Report: TAB Report
Function: Test, Adjust, & Balance
Date: 03/19/2025
Completed By: National TAB

PROJECT
03-17-25 CAVA TEMECULA, CA (REDHAWK)

Project: 03-17-25 CAVA TEMECULA, CA (REDHAWK)

- HOOD SIDE PANELS NOT INSTALLED
- KEF GREASE CUP

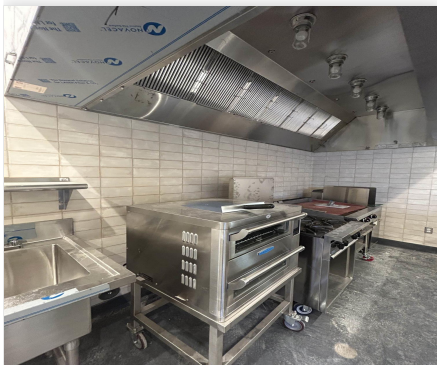
Issue Name : HOOD SIDE PANELS NOT INSTALLED
Description : Hood left vertical side panels have not been installed. Recommend installing panels as shown in the MSET.
Created By : National TAB **Assigned To :** National TAB - Dan Hertenstein
Status : Open
Priority : Medium **Asset Tag :**
Originated Date : 03/19/2025 - David Nicolas Sanchez - National TAB

Issue Name : KEF GREASE CUP
Description : KEF grease cup is not installed. Recommend installing grease cup to prevent grease from dripping on the roof.
Created By : National TAB **Assigned To :** National TAB - Dan Hertenstein
Status : Open
Priority : Low **Asset Tag :**
Originated Date : 03/19/2025 - David Nicolas Sanchez - National TAB
